WILLIAMSON COUNTY, TEXAS

CHANGE ORDER NUMBER: 2

RM 620 Phase 2 Williamson County Project No. 1608-108

Change Order No. 2

PLAN PROFILE

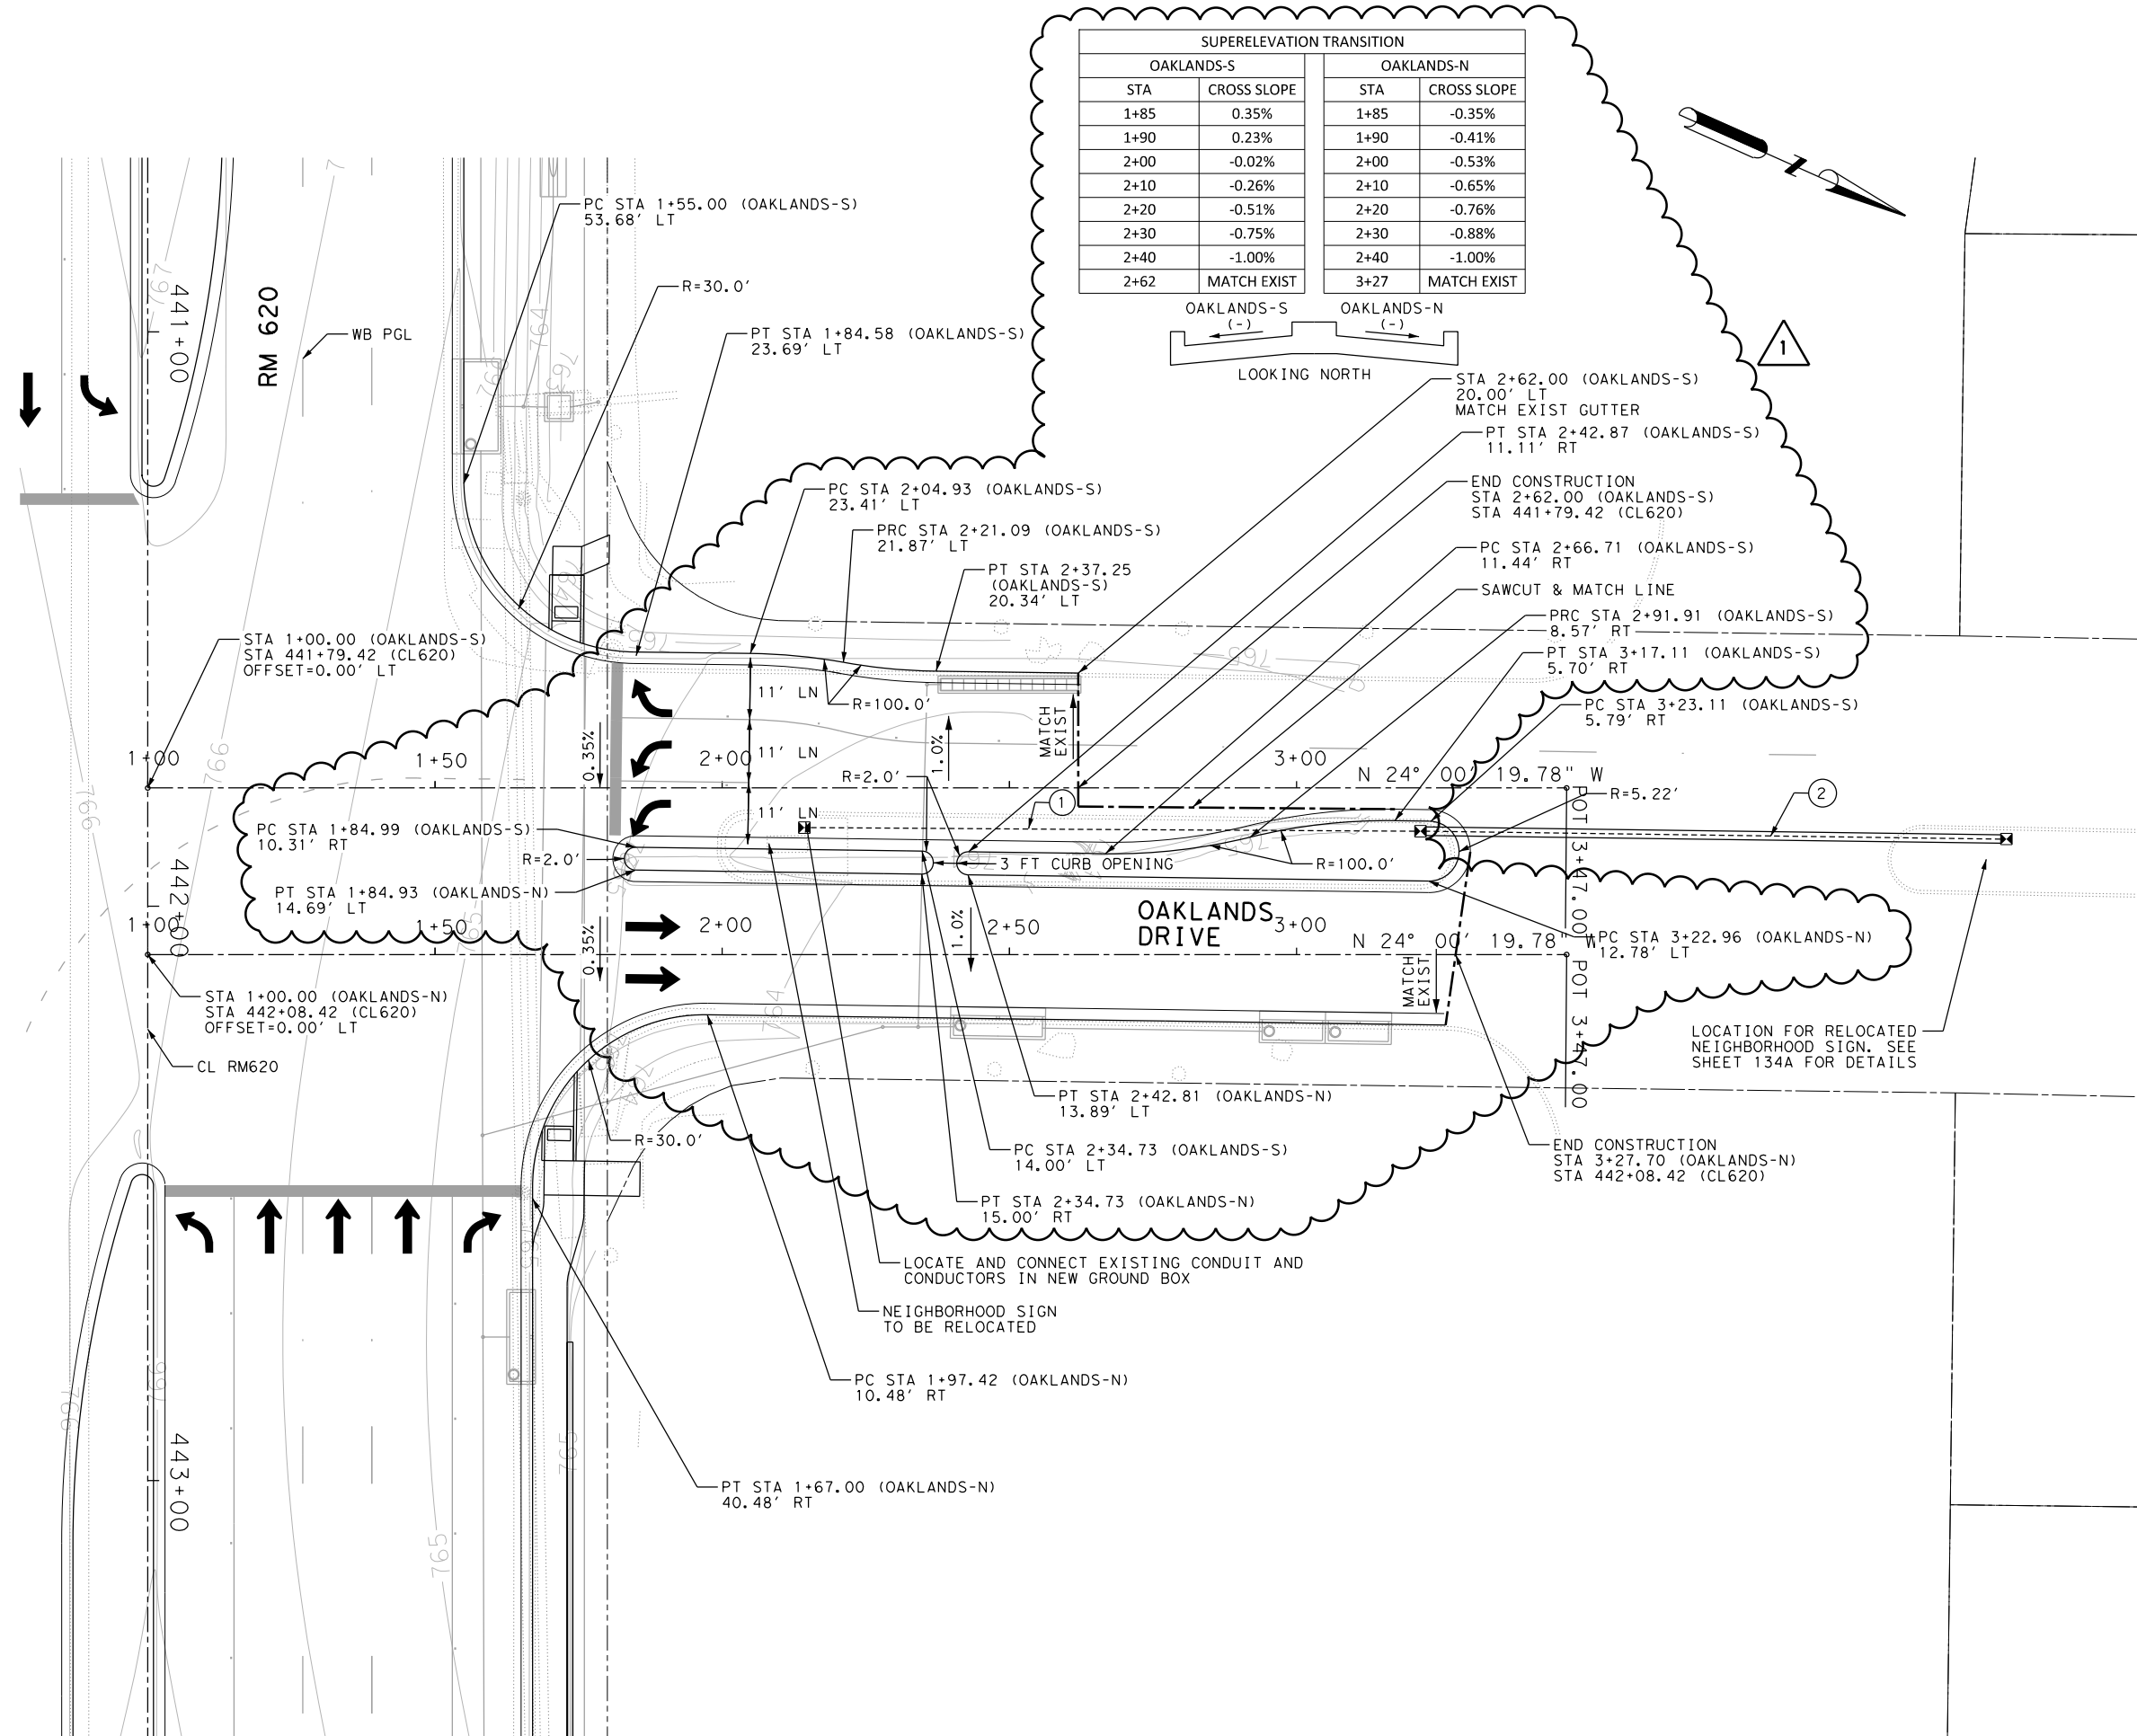
Plans show installation of curb inlet OL-MED at Sta. 2+48 along the center median. We have confirmed with survey that the existing roadway does not drain to the center median, it drains to the outside curb line. The inlet proposed for the center median will not catch any runoff.

We agree that the inlet in the median is not needed, but gutter flow on the outside curb needs to be handled (the TIN and contours provided by TxDOT were not accurate in this area). After meeting in the field to view marked utilities, it is clear that the curb inlet can't be installed on the outside (west) curb without conflicting with utilities and causing delay. So we are deleting the curb inlet and adding a new linear grate inlet (new detail sheet 199A) on the outside curb. Revised sheet are attached and the related quantity changes will follow in a separate response tomorrow.

GRATE DRAIN

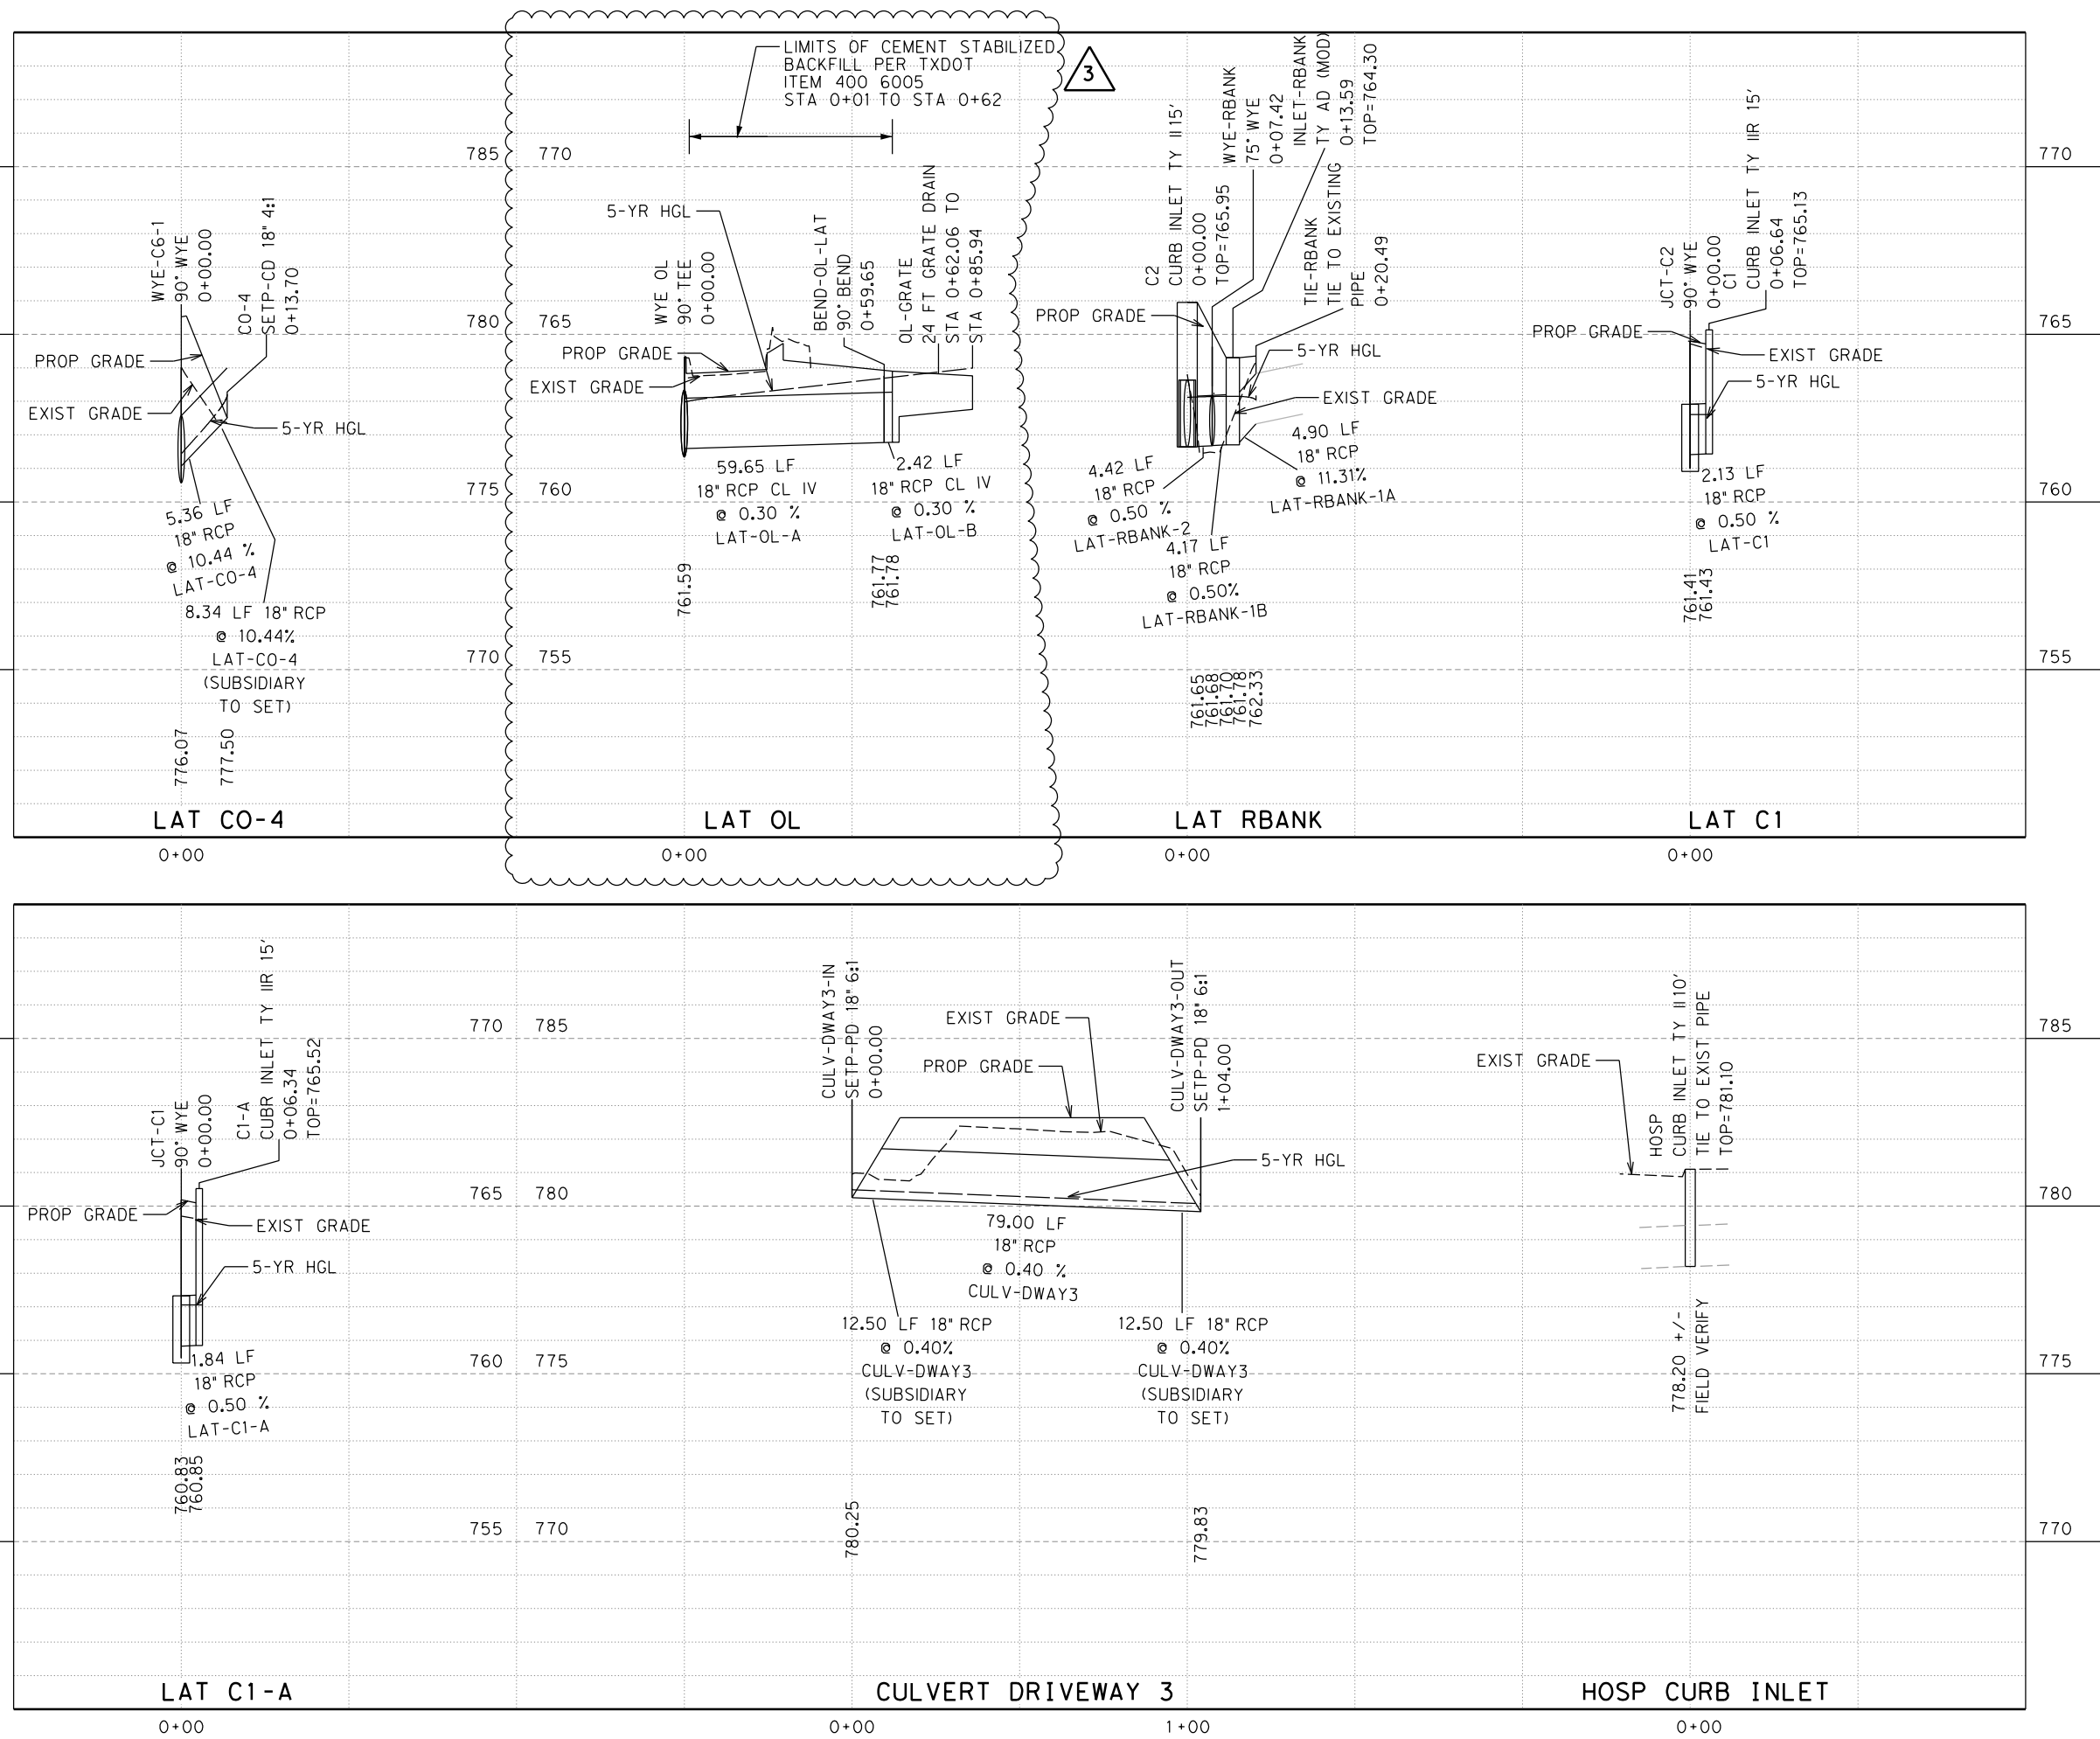
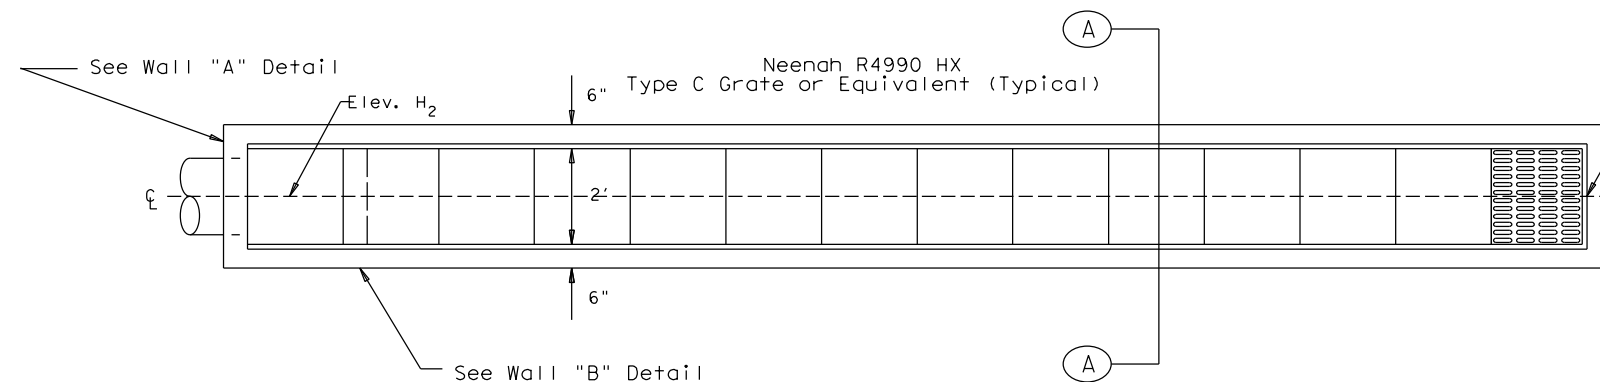
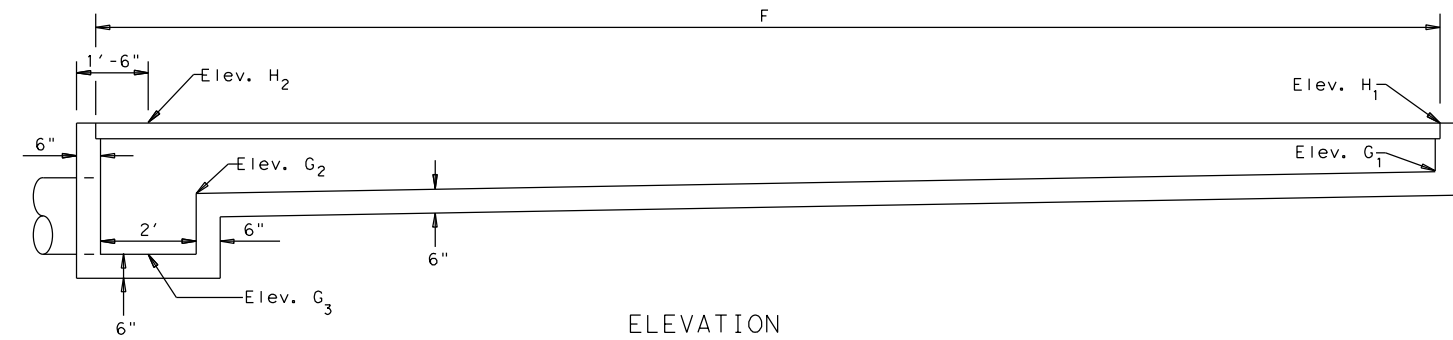
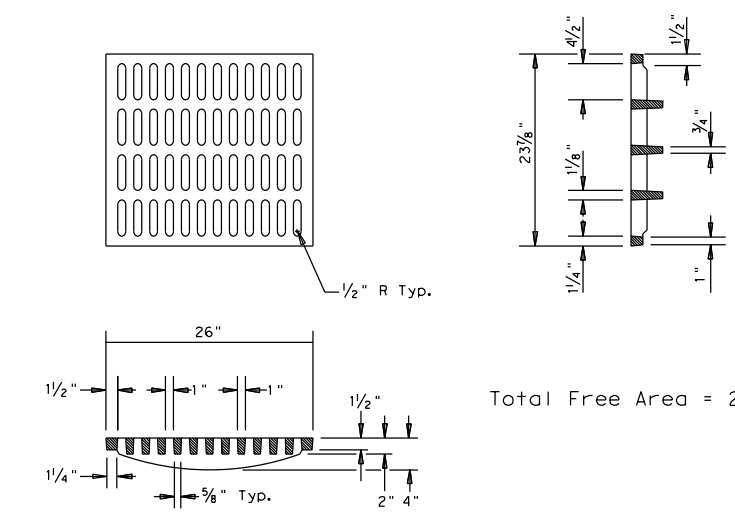
The plans show installation of curb inlet in the median at Oaklands Drive, however the survey confirmed that the roadway drains to the outside curb line. The inlet in the median is not needed, but a linear grated inlet was proposed to be installed along the outside curb line to accommodate the existing flow. A price proposal was submitted by the Contractor and accepted.
